Licence Number	L8747/2013/1
Licence Holder	Shire of Boddington
File Number:	2013/001944-1
Premises	Boddington Refuse Disposal Site Lot 71 on Plan 242990 Robins Road BODDINGTON WA 6390
Date of Amendment	5 July 2019

Amendment

Amendment Notice

Liquid Waste Ponds Map

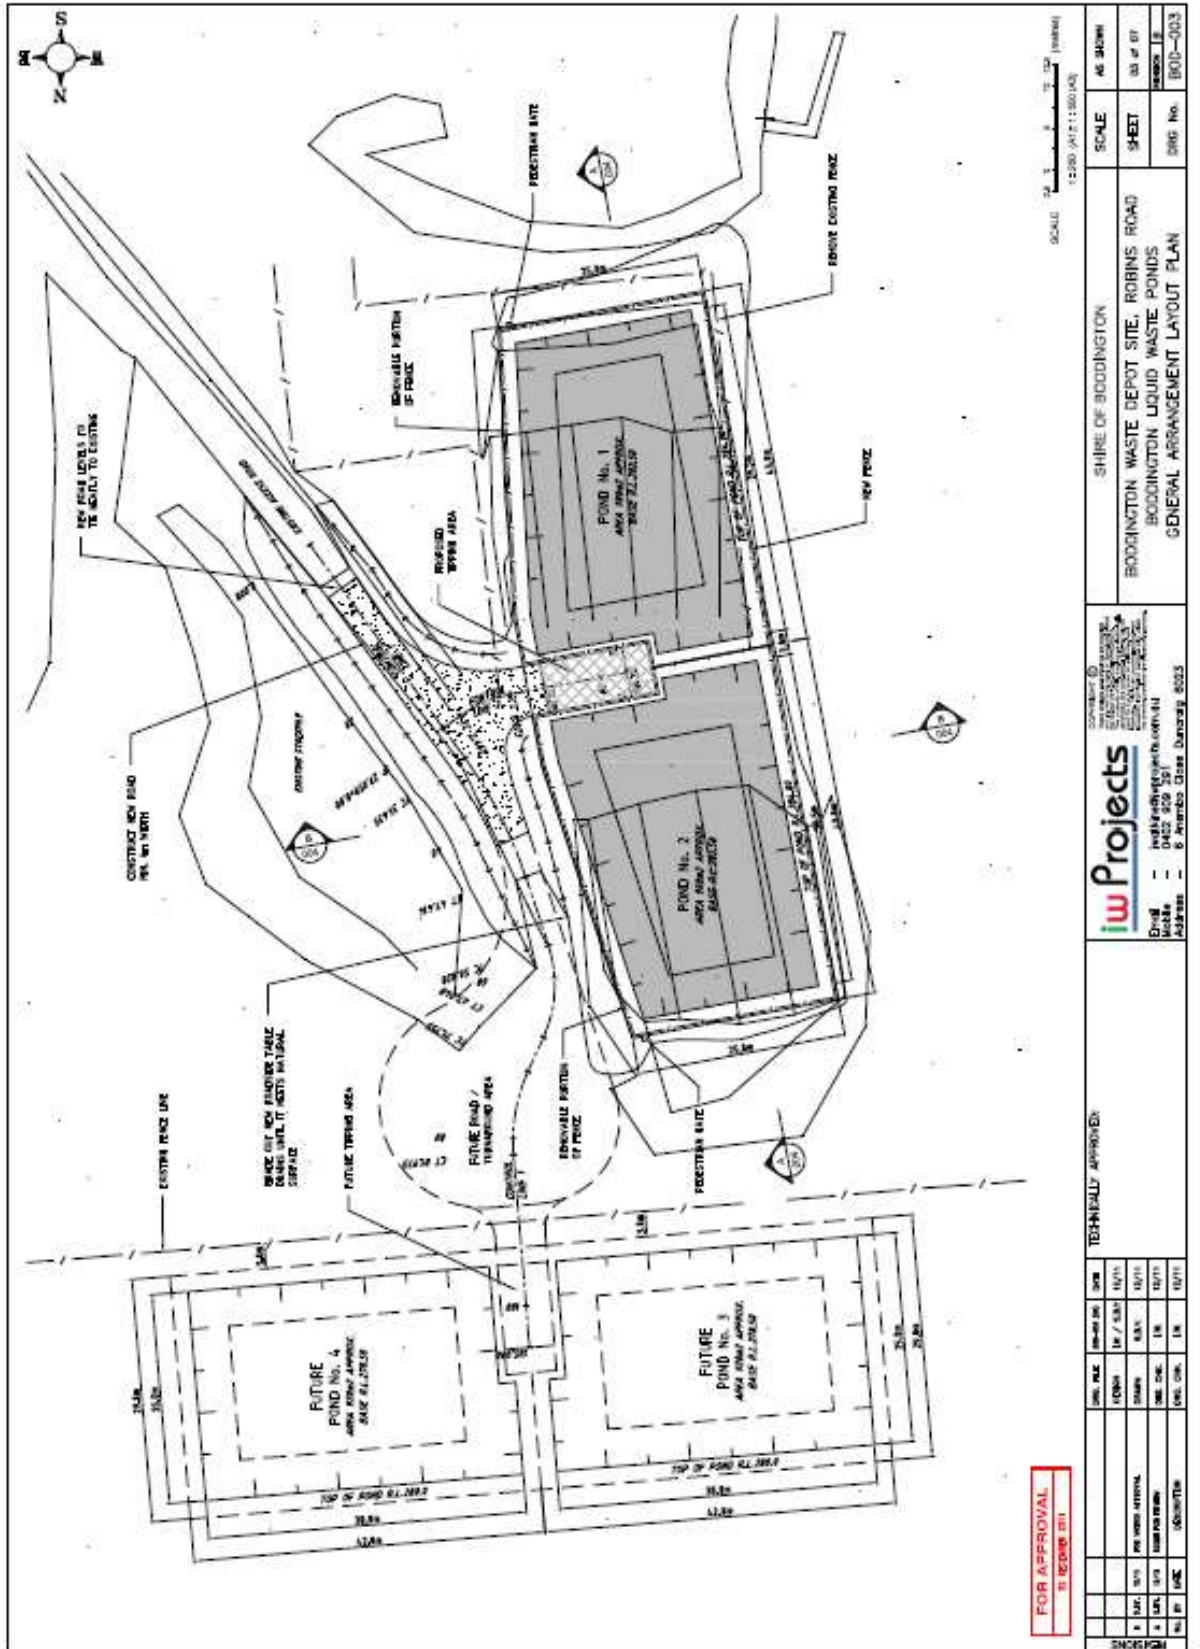
3. The Licence is amended by the addition of the following Map in Schedule 1: Maps.
